**Item 1**
**31 Pellisier Road, Putney - LDA2022/0372**
**Proposal: Alterations and additions to existing dwelling.**
**Report prepared by:** Assessment Officer – Building Surveyor

**City of Ryde  
Local Planning Panel Report**

<b>DA Number</b>	LDA2022/0372
<b>Site Address &amp; Ward</b>	31 Pellisier Road, Putney East Ward
<b>Zoning</b>	R2 Low Density Residential
<b>Proposal (as amended)</b>	Alterations and additions to existing dwelling.
<b>Property Owner</b>	Kerolos Zaki
<b>Applicant</b>	Mr Ji Aoun Design & Building Group Pty Ltd
<b>Report Author</b>	Jane Tompsett
<b>Lodgement Date</b>	23 November 2022
<b>Notification - No. of Submissions</b>	One (1) submission received (original plans) One (1) submission received (amended plans)
<b>Cost of Works</b>	\$85,000.00
<b>Reason for Referral to LPP</b>	Departure from Development Standard: The proposed development results in a 12.4% departure from the development standard for height of buildings imposed by Clause 4.3 of RLEP 2014.
<b>Recommendation</b>	Approval

Figure 17: Shadow at 9am

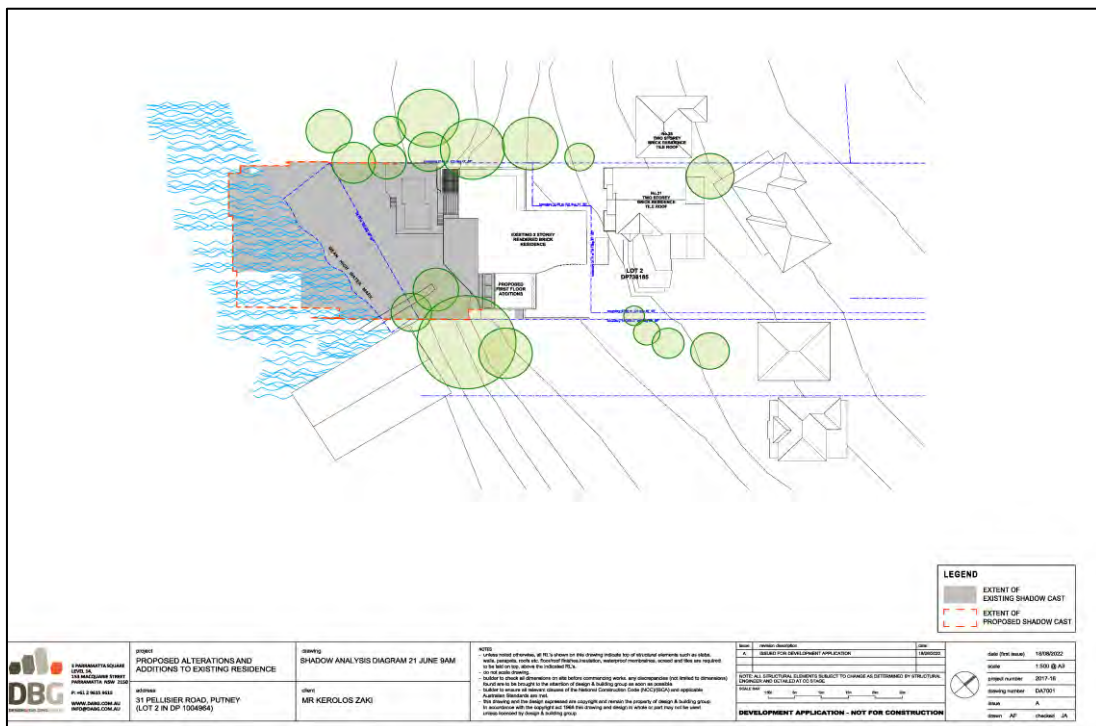
**Assessment Officer's Comments:** The additional overshadowing from the proposal has the potential to impact the adjoining neighbour, No. 33 Pellisier Road. The submitted shadow diagrams show the neighbouring dwelling's private open space area receives adequate solar access from 9am to midday. The north-west and north-east side walls have no additional overshadowing by the proposed first floor addition. The proposal is compliant for daylight and sunlight controls. No. 35 Pellisier Road has a small portion at the very rear of site along the foreshore that is affected by shadow at 3pm and is compliant with Council's control. The proposed development maintains appropriate sunlight access to neighbouring dwellings and neighbouring private open space.

**Figure 22:** View loss assessment 5 & 6. The existing Tree canopy at 33 Pellisier Road shaded in grey partially obscured. The white area adjacent the water is the portion of the water view loss.

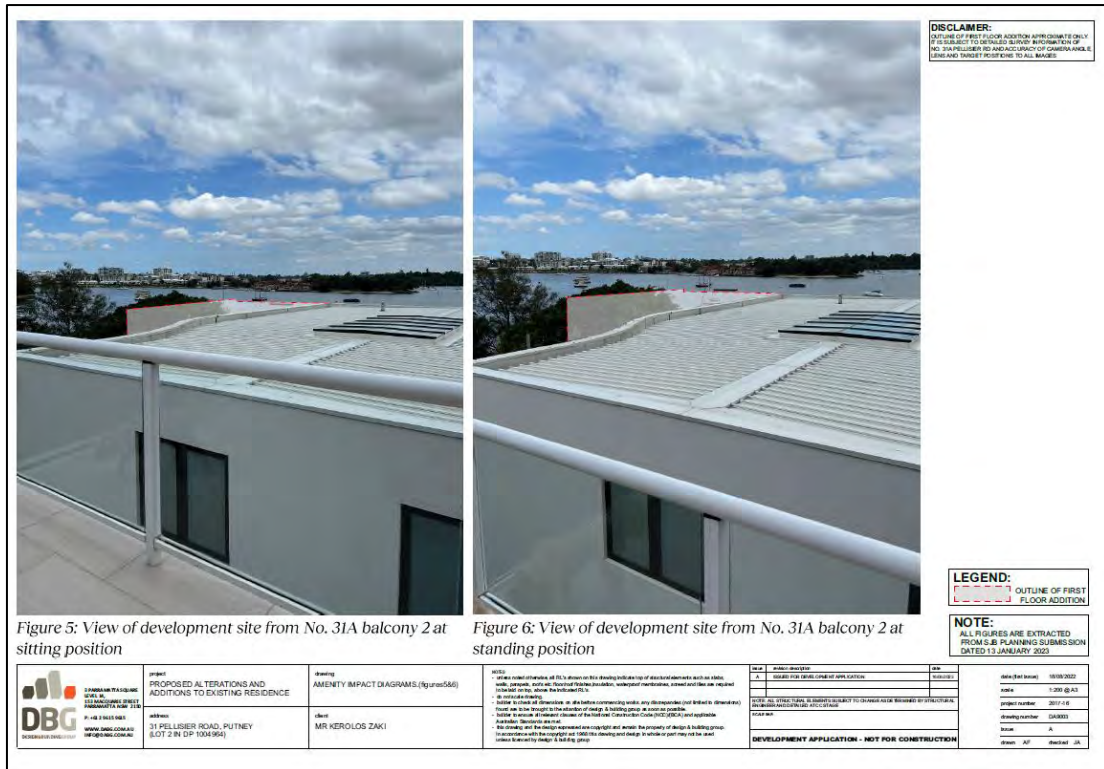
Assessment Officer's Comments: The immediate surrounding properties include No. 31A Pellisier Road which is a two storey dwelling. No. 33 & 35 Pellisier Road is owned by The Kings School and has a large Boatshed. Development in the locality is primarily for residential and educational purposes. Residential development in the locality is characterised by relatively large single detached dwellings of diverse architectural styles whilst the educational facilities are smaller scaled buildings on larger lots. The proposal results in a built form and envelope that is consistent with residential development in the streetscape and is appropriate in the local context. The view loss analysis has been done for the adjoining neighbour at 31A Pellisier Road. The proposal will result in a minor reduction of the existing foreshore view as demonstrated below.

**Figure 24 – Proposal in relation to foreshore building line (red dashed line represents the foreshore building line).**

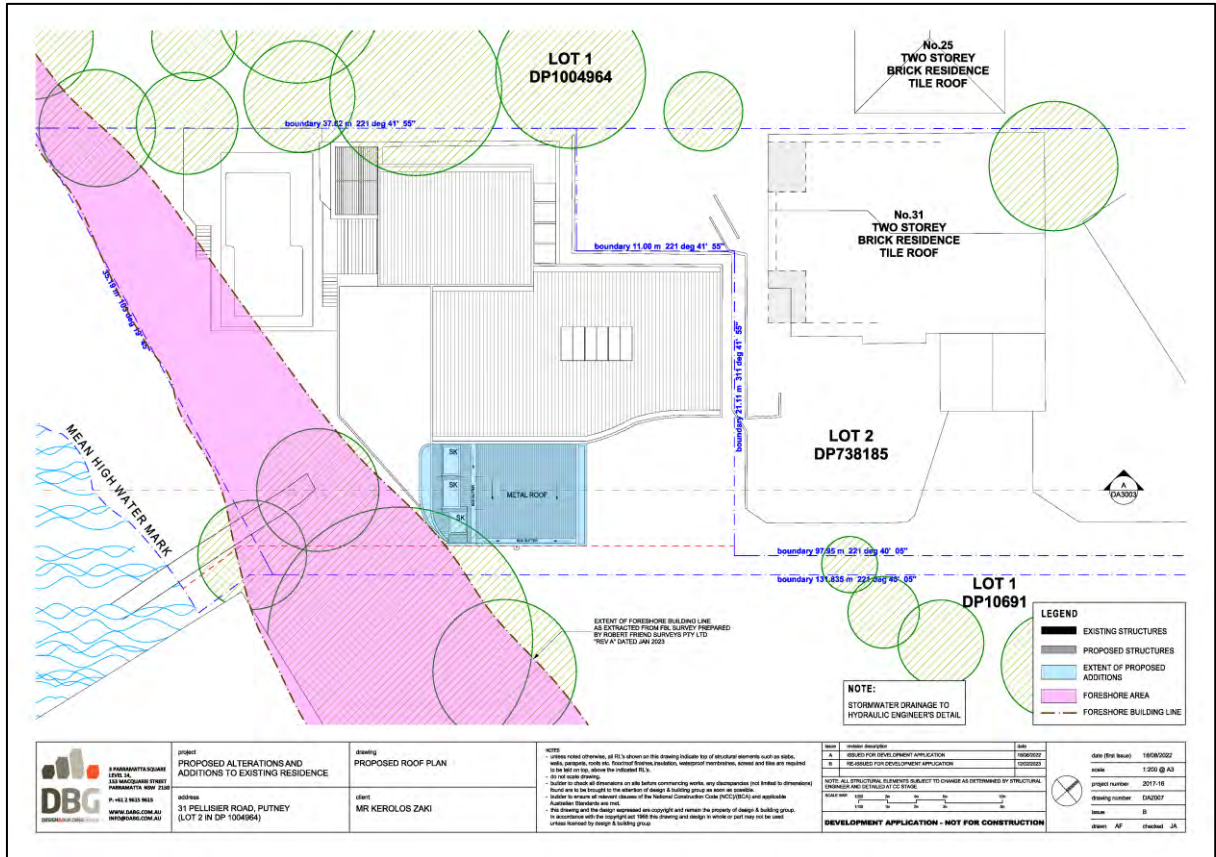
The site is subject to the foreshore building line which is shown in **Figure:24** below.

**Figure 27– 3D aerial 31 Pellisier Road**

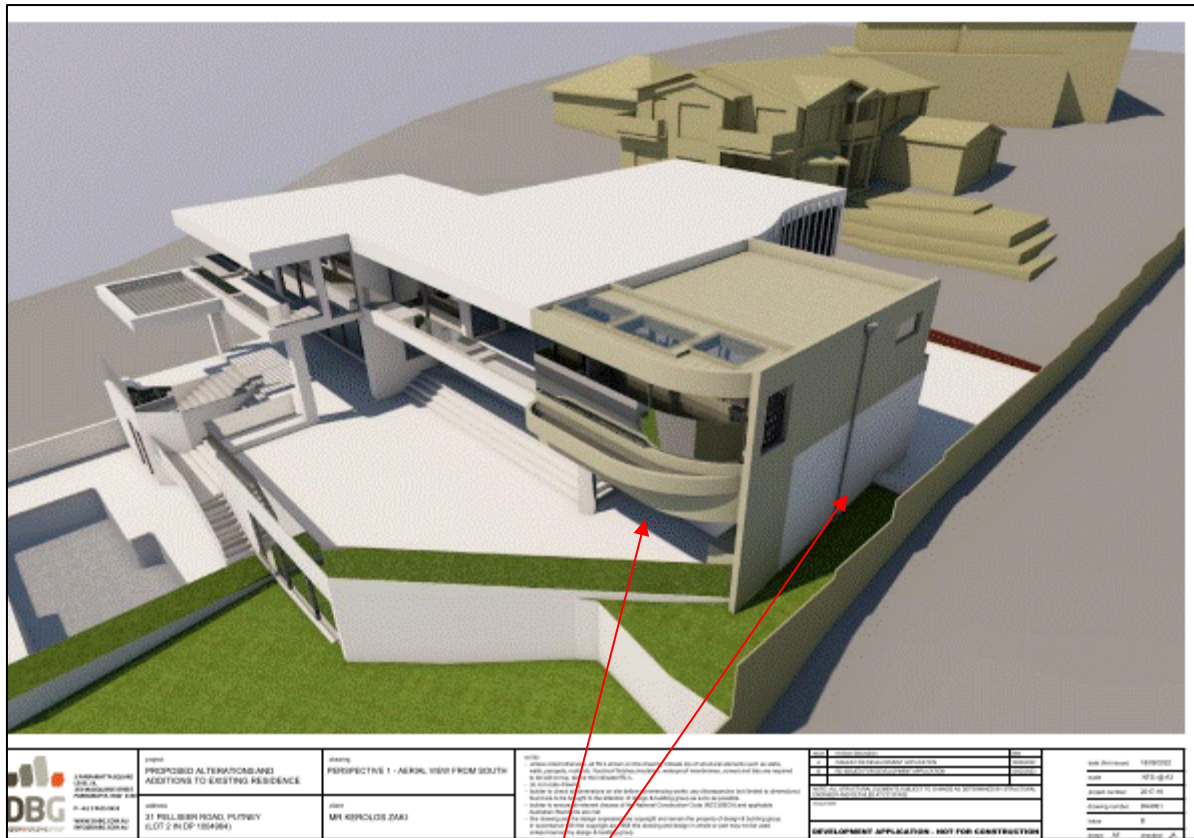
The part three storey section is below the existing ground level shown above. The as constructed dwelling has the existing basement with retaining walls and is terraced down the site. The new first floor addition is above the existing finished ground floor podium level. The addition extends the existing dwelling height above the podium level towards the side boundary in line with the existing 2m side setback. The wall plate height and side setbacks are compliant with Council’s controls. The bulk and scale of the addition is consistent with a two story building when viewed from the front and the rear providing a consistent first floor height across the site. The wall plate height of the building is compliant with Councils DCP

**Figure 28:** Amended Foreshore Building Line Survey dated 23 January 2023

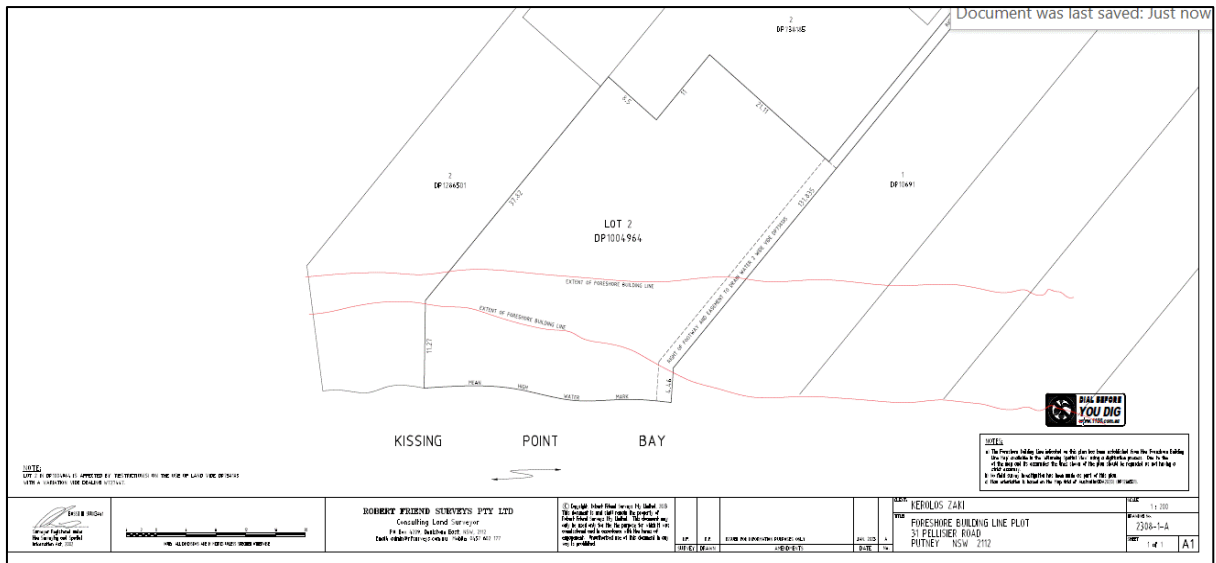
The applicant provided an amended survey and plans regarding the foreshore building line. The development complies with the foreshore building line as demonstrated in the following figures.
